ADDENDUM NUMBER FOUR

NEW COMPLEX FOR WASHINGTON COUNTY ROAD & BRIDGE

BRENHAM, TEXAS

October 26, 2018

2 FLOOR PLAN - TIRE & SIGN STORAGE BUILDING 1/8" = 1'-0"

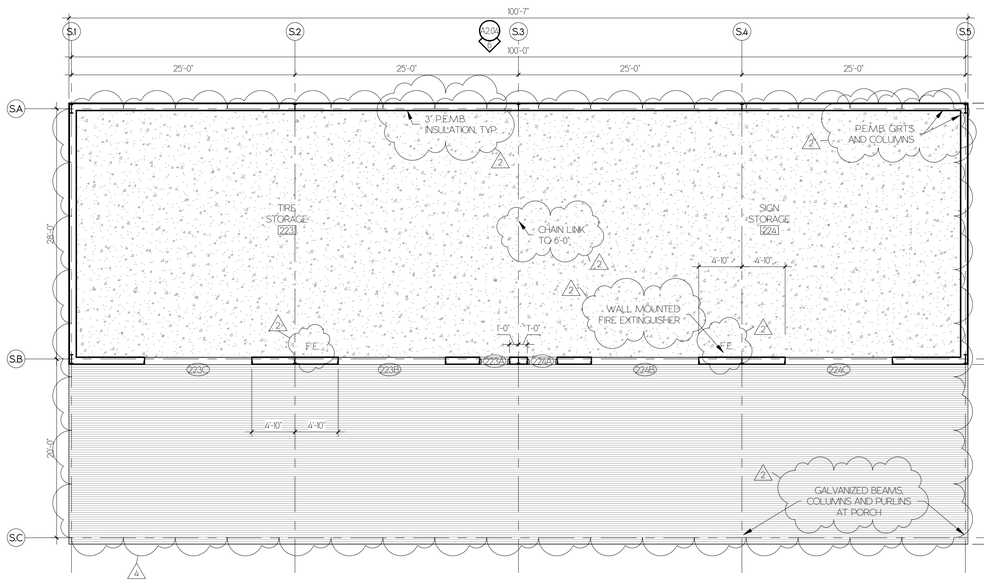
3. *A2.04 TIRE & SIGN STORAGE BUILDING* –Polished Concrete remains inside the building. Porches to be BROOM FINISHED. Replace Sheet A2.04.
4. *A9.01 DOOR TYPES AND WINDOW TYPES / SCHEDULE* – Add Hardware Set 8.0 to Doors 223A and 224A. Replace Sheet A9.01
5. *A11.02 COMPOSITE FIRST FLOOR AND SECOND FLOOR FINISH PLANS* – The following areas are to be broom finished: Washbay 214, Covered Porch 216, Covered Porch 215,

2 SECOND FLOOR FINISH PLAN 1/8" = 1'-0"

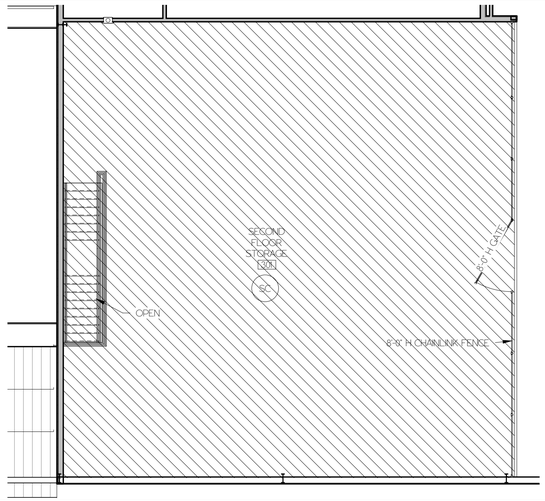
Breezeway between buildings, and the front porch at office building's Main Entry. The Second Floor Storage 301 is to be Sealed Concrete. Replace Sheet 11.02.
